## PUBLIC COMMENTS FOR IBR PROGRAM COMMUNITY ADVISORY GROUP-NOVEMBER 4, 2021 MEETING

Received between August 31 - November 2, 2021

Figure 4. Stacked alignment option

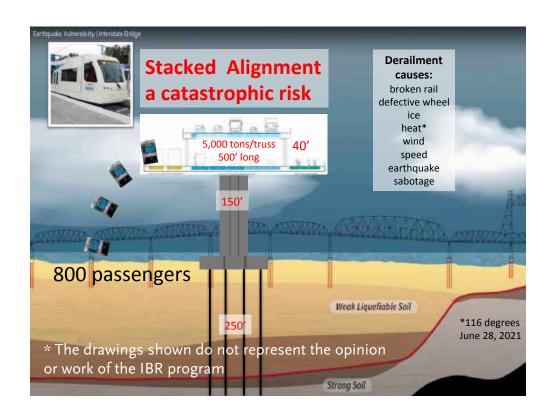
The IBR's "Stacked alignment option" has at least three major problems.

# 2. Asymmetrical loading

250 tons- asymmetrical loading

asymmetric load

500-foot truss span
